HAWP 35-88.

APPLICATION FOR HISTORIC AREA WORK PERMIT

Staff Review Form

LOCAL ADVISORY COMMITTEE REVIEW FORM

Model 1

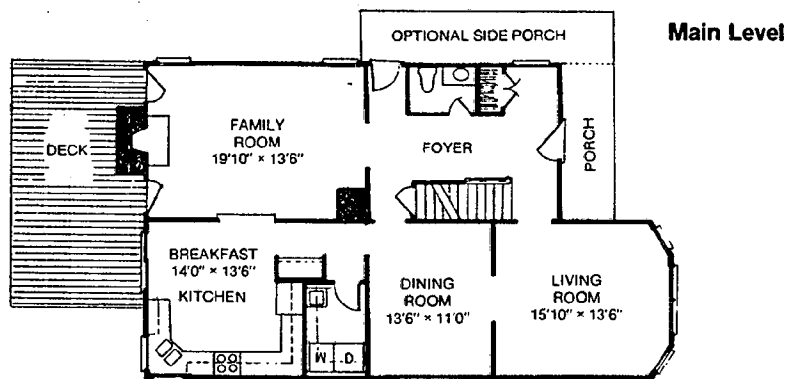
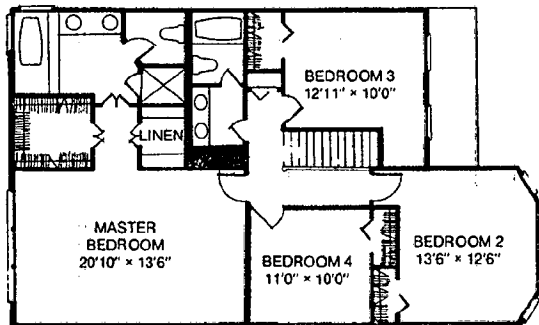
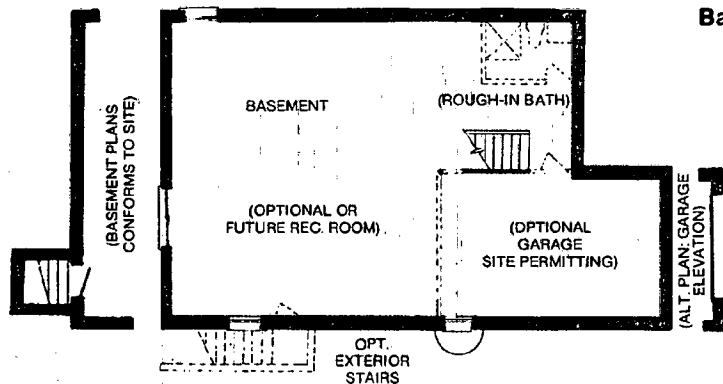
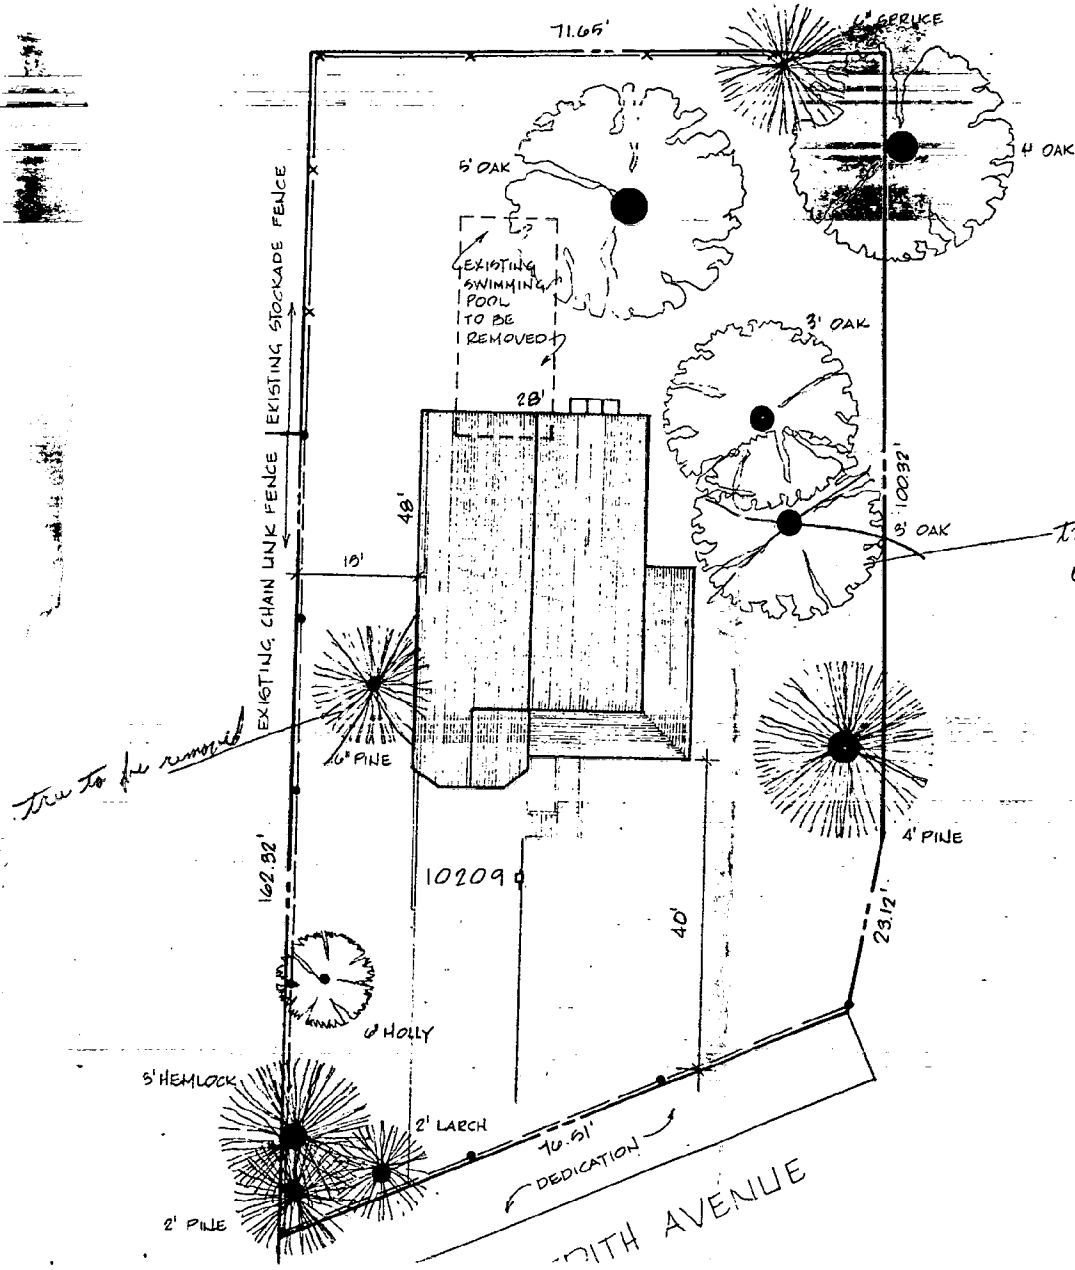
1. Lattice between porch and grade
2. Porch stair risers, porch railings and posts to be painted to match trim of house (floor to be option of builder/buyer)
3. Exposed foundation painted to match siding
4. HPC arborists survey trees and identify those trees that can be saved given such considerations as safety of the property, especially the large ones.

- (1) lattice between porch and grade.*
(2) Porch step risers, porch railings and posts to be painted to match trim of house... (floor to be option of builder/buyer)
(3) Exposed foundation painted to match siding.
*(4) #PC have their arborist survey trees and identify these ***

SITE PLAN
 1"=15'

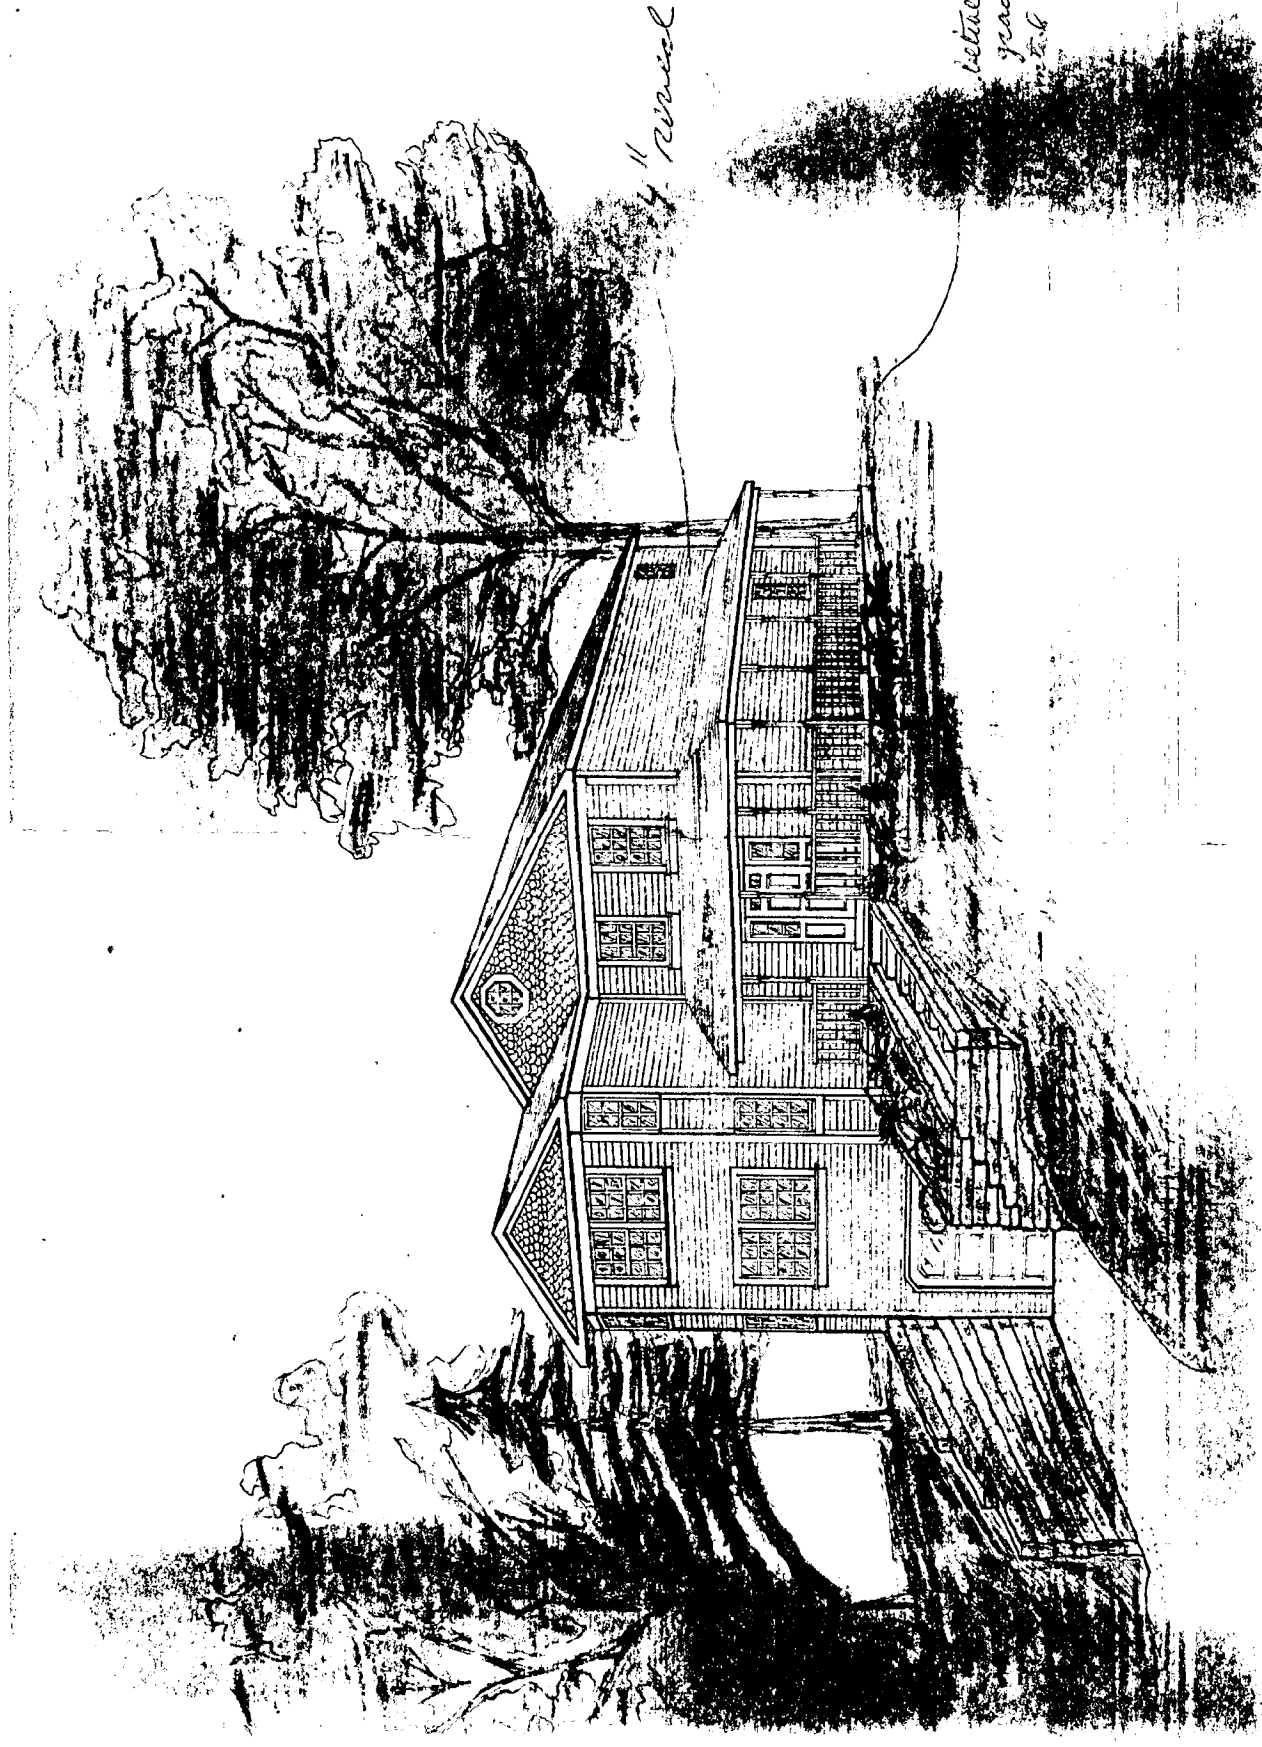
*this tree will probably have to come down
 due to root damage & leaning of tree into house*

tree to be removed

Construction of new house/removal existing swimming pool, site plan indicates removal of 2 trees. LAC recommends approval with conditions as follows: 1) lattice between porch and grade 2) porch risers, railings and posts painted to match house trim 3) foundation painted to match siding 4) HPC have arborist survey trees on site to identify those that can be saved, particularly the large oaks.

Photos indicate another house at 10203 Meredith Lane. How does that house relate to new house? Owner should provide drawing showing relationship. Owner needs to propose measures to save the oak identified on the site plan. Suggest approval with conditions per LAC if applicant addresses questions noted satisfactorily.

Approval also includes a snow fence around rear tree during construction. It does not include driveway, grading, and retaining walls, for which another site plan is necessary.

SITE PLAN
1"=15'

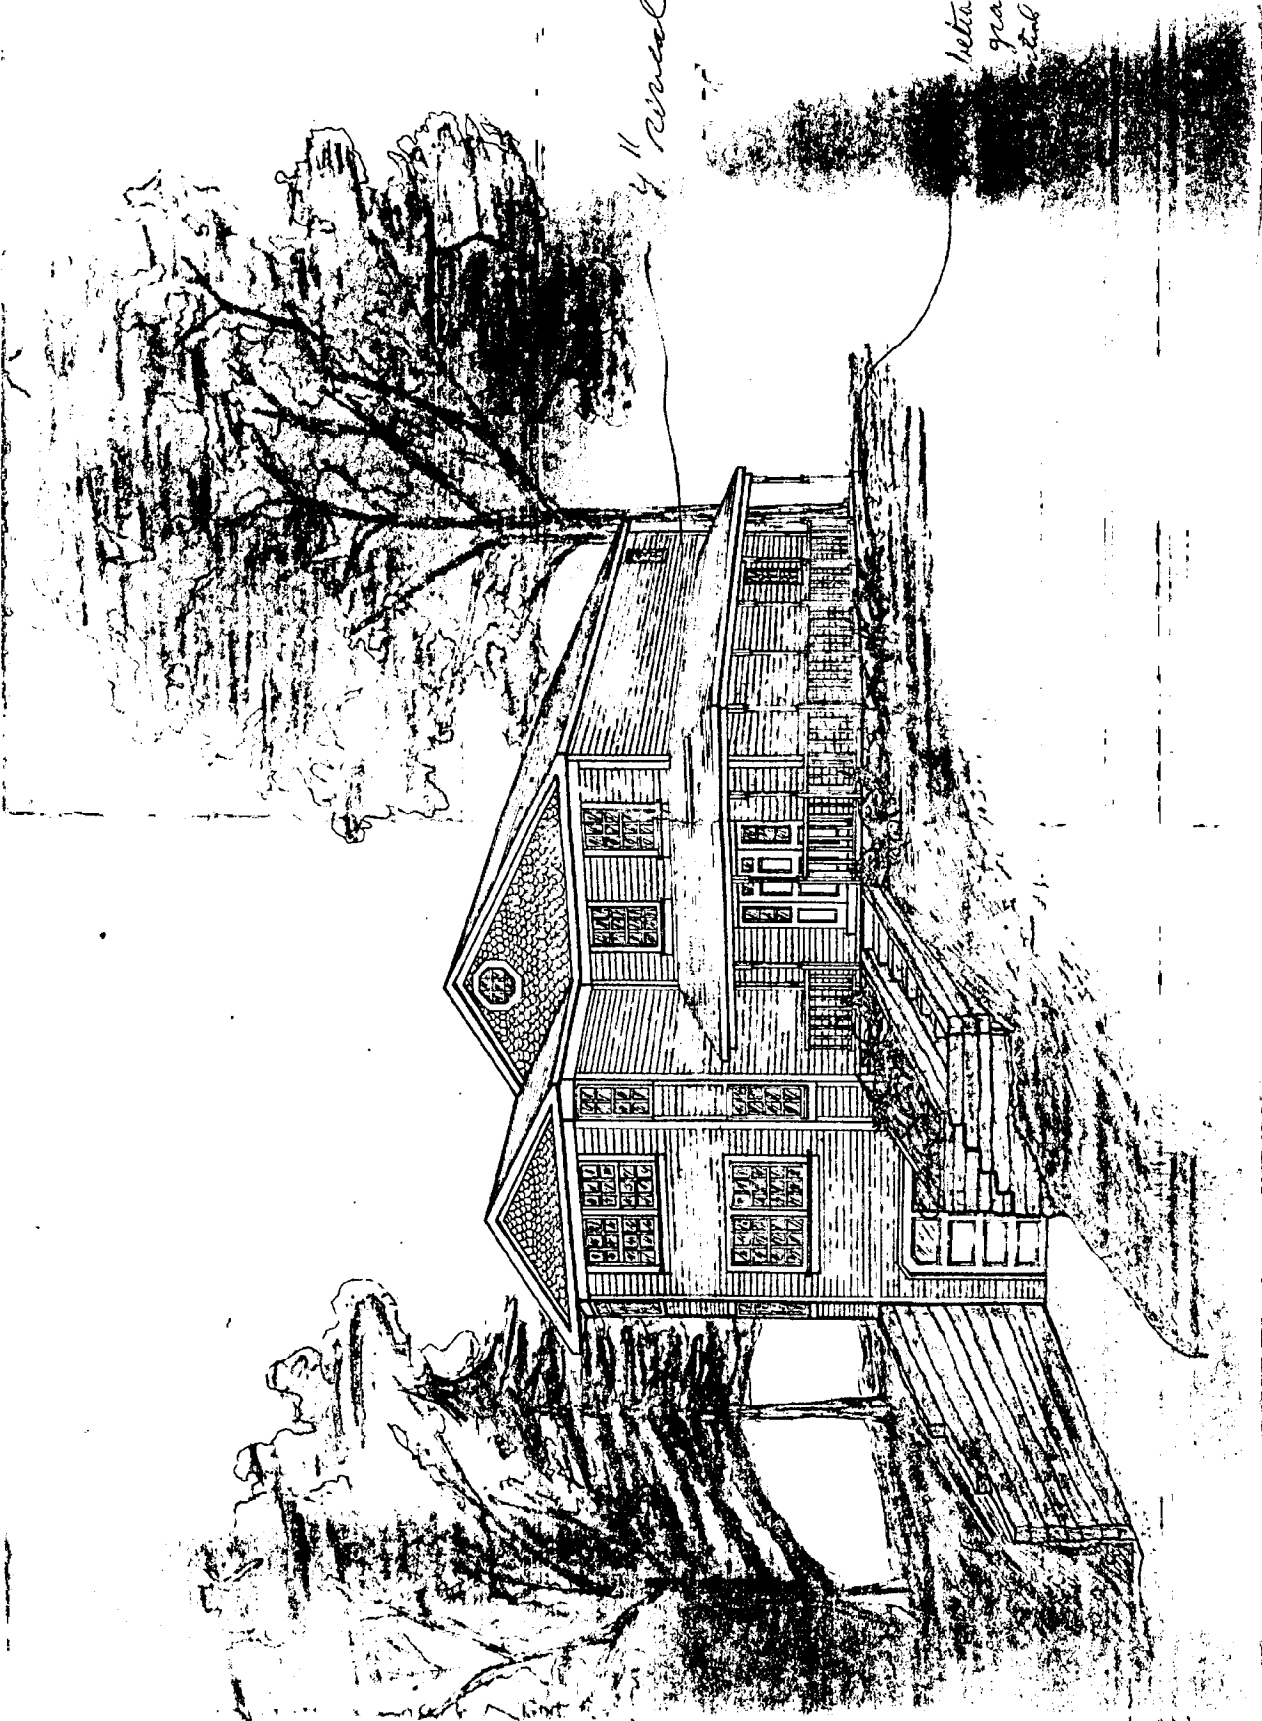
*the tree will probably have to come down
do to root damage & leaning of tree into house*

Construction of new house/removal existing swimming pool, site plan indicates removal of 2 trees. LAC recommends approval with conditions as follows: 1) lattice between porch and grade 2) porch risers, railings and posts painted to match house trim 3) foundation painted to match siding 4) HPC have arborist survey trees on site to identify those that can be saved, particularly the large oaks.

Photos indicate another house at 10203 Meredith Lane. How does that house relate to new house? Owner should provide drawing showing relationship. Owner needs to propose measures to save the oak identified on the site plan. Suggest approval with conditions per LAC if applicant addresses questions noted satisfactorily.

Approval also includes a snow fence around rear tree during construction. It does not include driveway, grading, and retaining walls, for which another site plan is necessary.
